TOWN OF MORRISTOWN DEVELOPMENT REVIEW BOARD
WARNED PUBLIC HEARING
COMMUNITY MEETING ROOM OF THE OLD TEGU THEATER
43 Portland Street in Morrisville, VT 05661
6:00 PM Wednesday, July 22, 2026

July 8th, 2026, DRB Meeting Staff Notes

APPLICATION: 2026-58

PROJECT DESCRIPTION: 2026 -59- Major Subdivision, and Conditional Use Review application submitted by Nick Manosh for a property located at 400 Ferland Pit Road. The Applicant is seeking Major Subdivision Review for a proposed 4 lot subdivision. The lots are as follows: Lot 1. 28.5 acres, Lot 2. 19.4 acres, Lot 3. 10.9 acres, Lot 4. 43.5 acres. The Applicant is also seeking conditional use approval for new gravel pits located on proposed Lots 1. & 2. The Applicant plans to phase the gravel pits in two phases. In addition, the Applicant is seeking to establish a water bottling plant on proposed Lot 3. This project will be reviewed under the 2023 Zoning Bylaws with emphasis on the following Sections: Section 204.5a-b, 485, Article V., 630, 660, 750, 760, 770, and Article VIII.

sheet title
FLOOR PLANS
ELEVATIONS

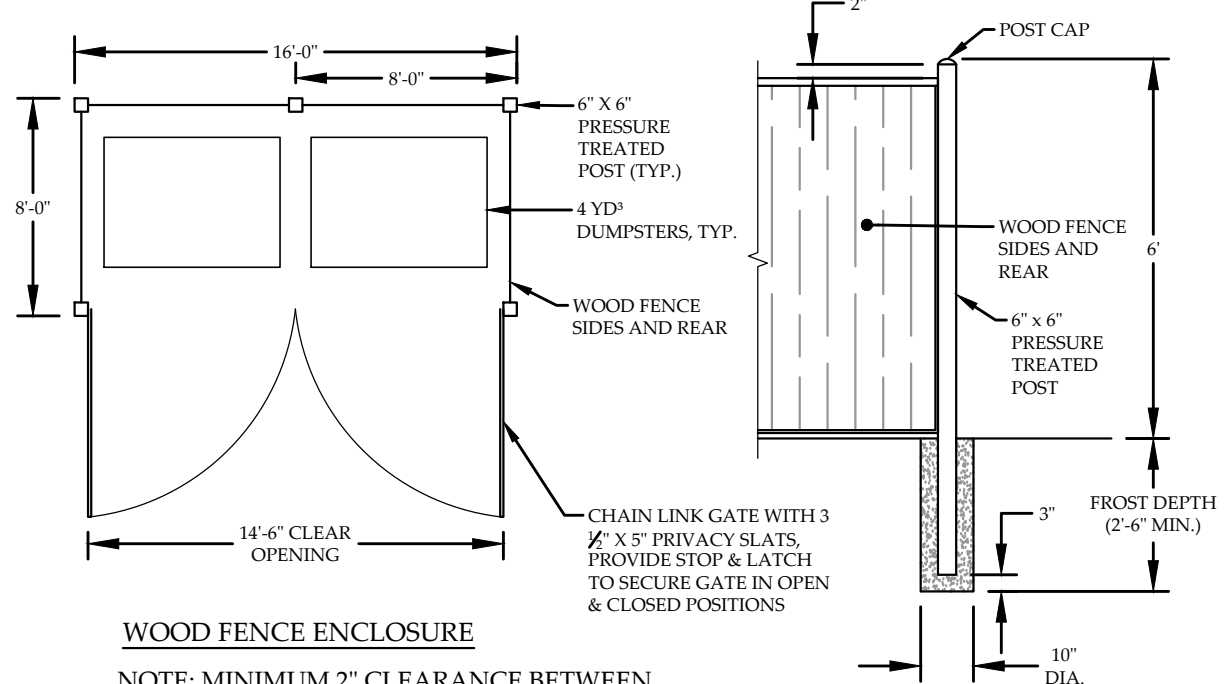
20. Section 207.C.2 notes that all building material shall be preferred building materials.
21. The Applicants architectural plans noted in Submittal C shows wood siding.

22. Section 207 C.11 notes the requirements for windows in the historic preservation district.
23. The applicant's site plan shows windows and notes that they will be double hung. The windows are also egress windows. The framing materials for the window are not noted. **(The Applicants will need to provide more detailed information on the windows to ensure they comply with the standards noted in this section).**

SITE PLAN

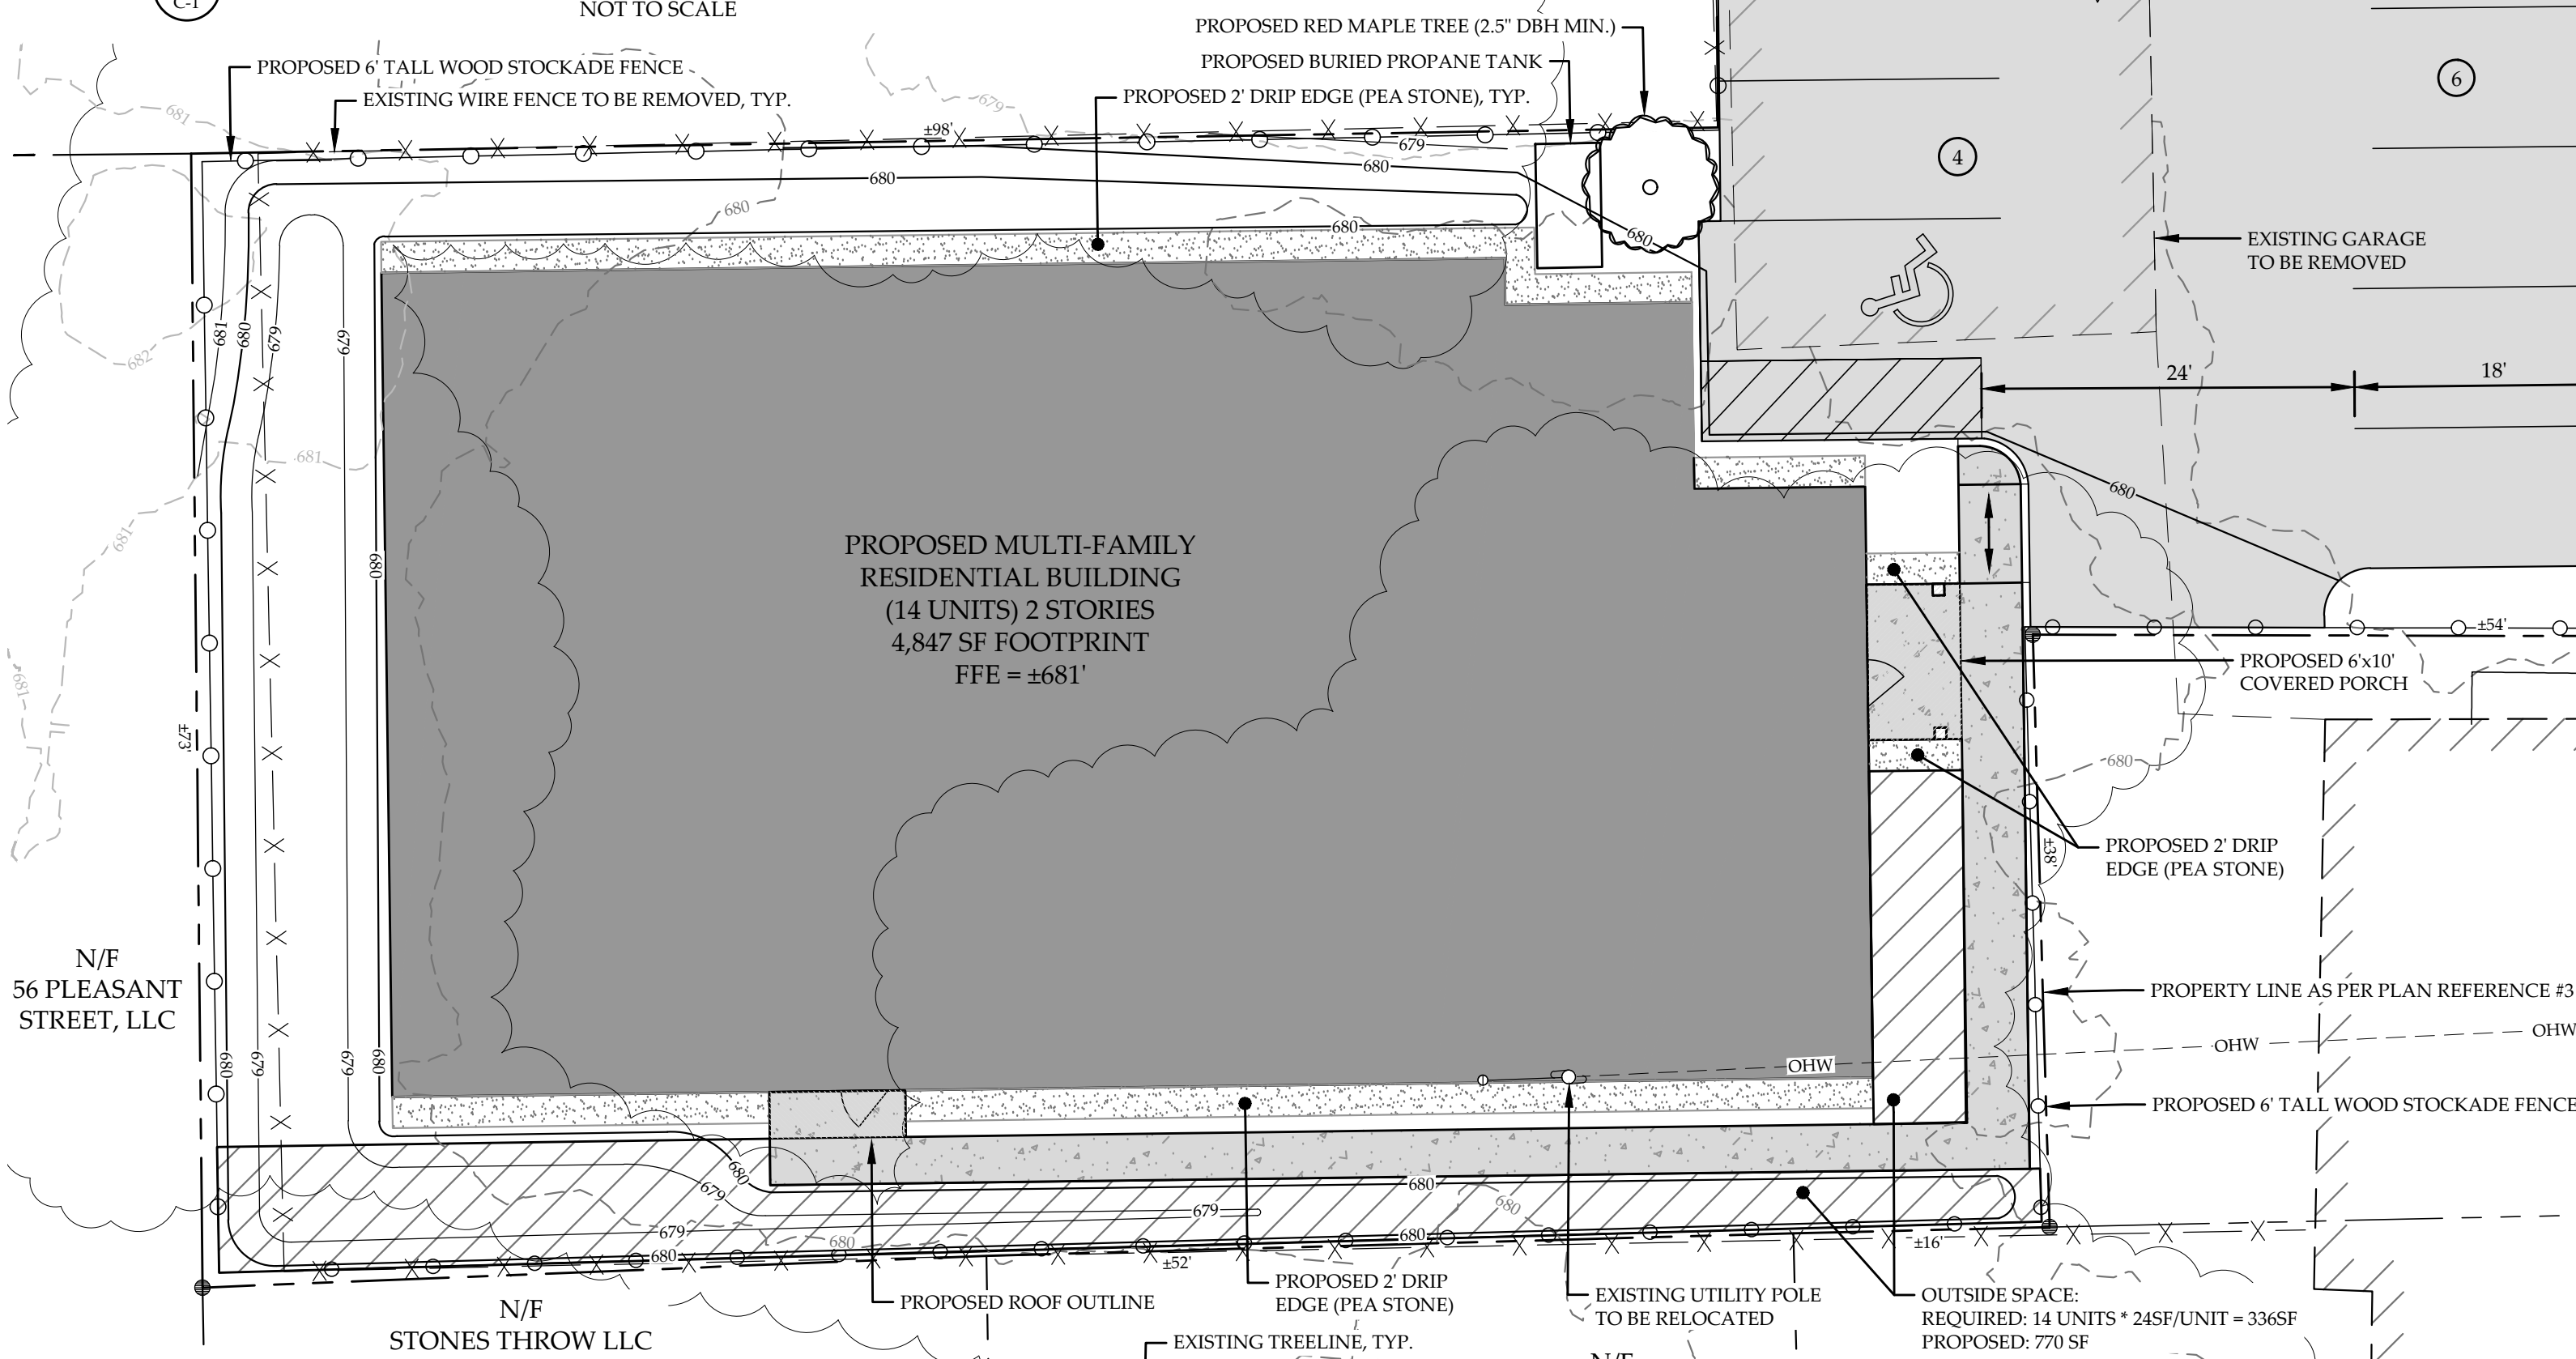
11. The Applicants site plan shows parking between the new building and park street. However, the parking is to the side of the existing building located at 5 Park Street. **(The board will need to determine if the parking needs to be located to the side or rear of the new proposed building or is it acceptable to have that parking located to the side of the existing building at 5 Park Street).**

15. The Applicants site plan shows 2 feet of gravel drip edge around the building. The parking area has no proposed stormwater infrastructure. **(The Board could consider requiring the applicant to provide a stormwater plan to ensure that water from the parking area does not infiltrate onto abutting properties with a particular emphasis on the library property and Park Street)**

16. Section 206.18 notes that utilities shall be located underground unless waived by the DRB for a reason other than cost.
17. The Applicants site plan shows overhead utilities (**The Applicants should update their site plan to show underground utilities, or they should request that the DRB waive this requirement for reasons other than cost.**)

28. The Applicants project complies with the following section of 500.B: 1,2,3,4,5,6.i, 6.iii, 6 6.v
29. The Applicants site plan does not show the location of propane tanks as noted in Section 500.B.6.ii.

30. The Applicants site plan does not show the location of clustered mailboxes as required by Section 500B.6.iv.
31. The Applicants site plan does not note how the building will be heated as required by Section 500B.6.v.

32. Section 505 notes that landscaping shall be required for any multi family housing uses.
33. The Applicants plan set shows landscaping for the site which includes 4 Armstrong maples. **(The Board could consider requiring additional landscaping if needed.)**

MIXED USE DEVELOPMENT
WATER BOTTLING PLANT
SITE PLAN

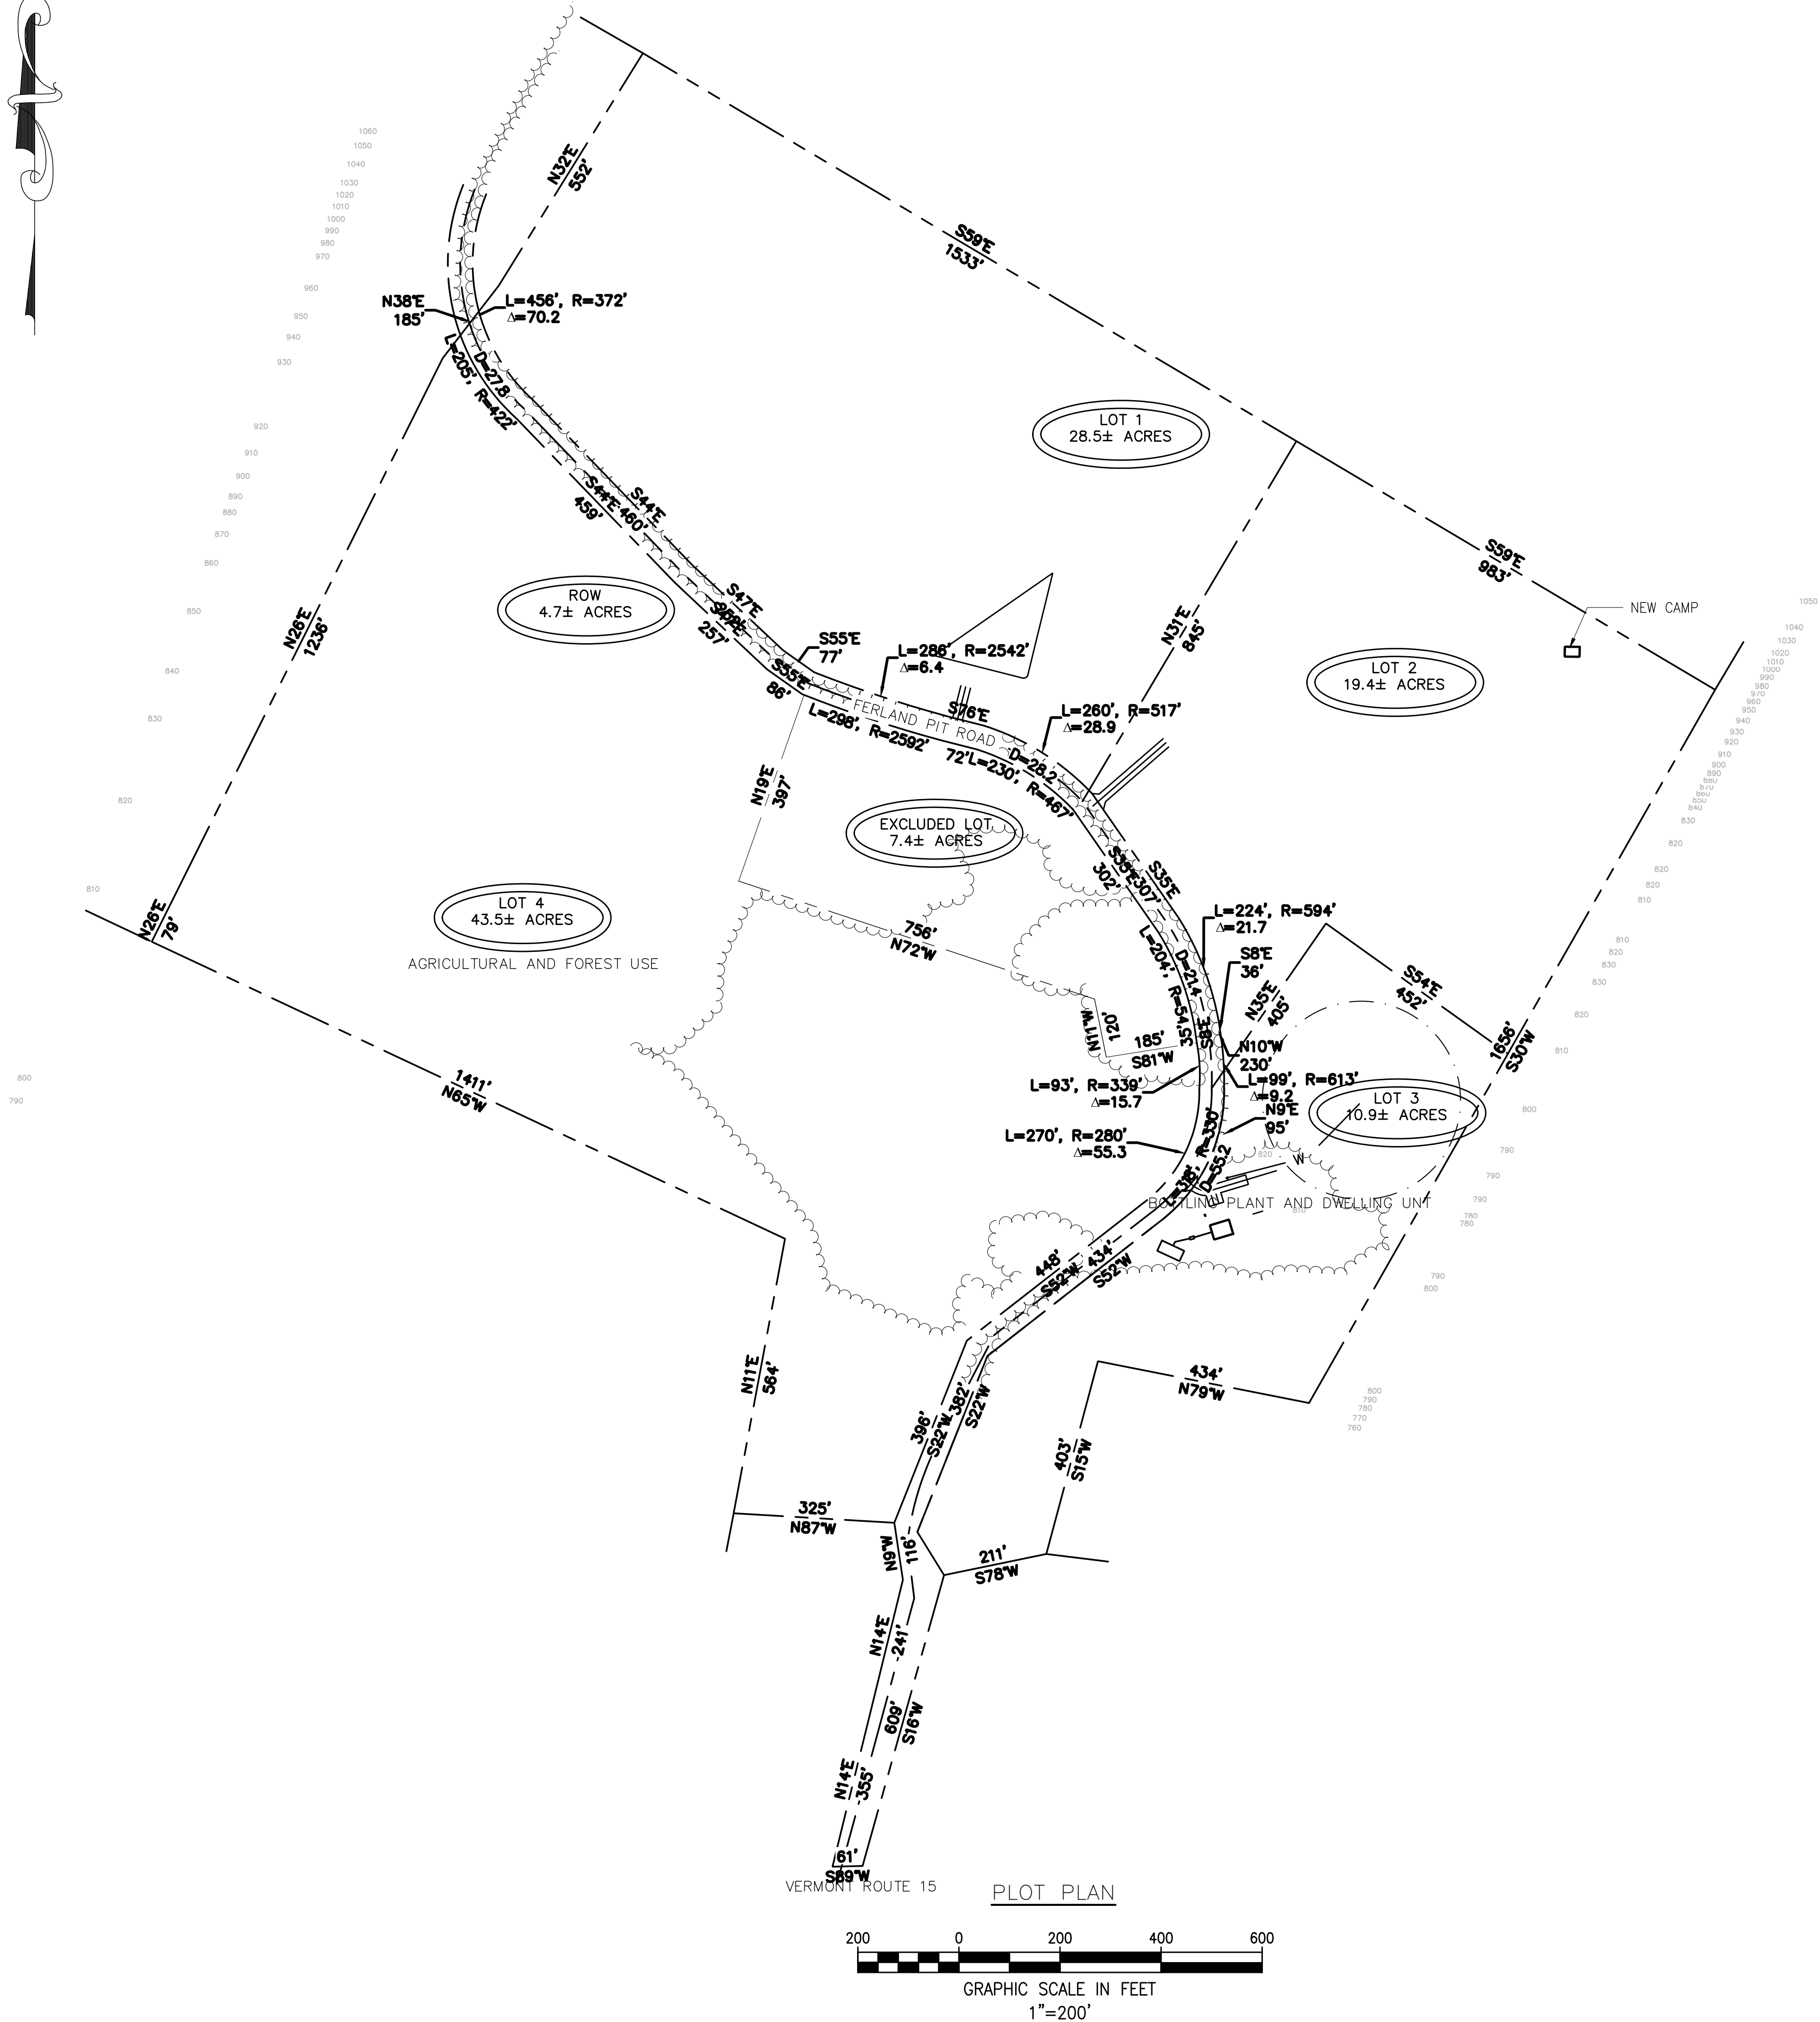
17. The Applicants plan set appears to show extraction within 200 feet of the southern property boundary of proposed Lots 1. In addition, Ferland Pit Road appears to be within 200 feet **(The Applicants should confirm this distance and reduce the extraction area if it is within 200 feet of this lot line or Ferland Pit Road.)**

19. The Applicant site plan does not show the location of any extraction machinery. **(The Applicants should confirm that no extraction machinery will be located within 300 feet of any property boundary. This is more of a concern for phase 2 of the project).**
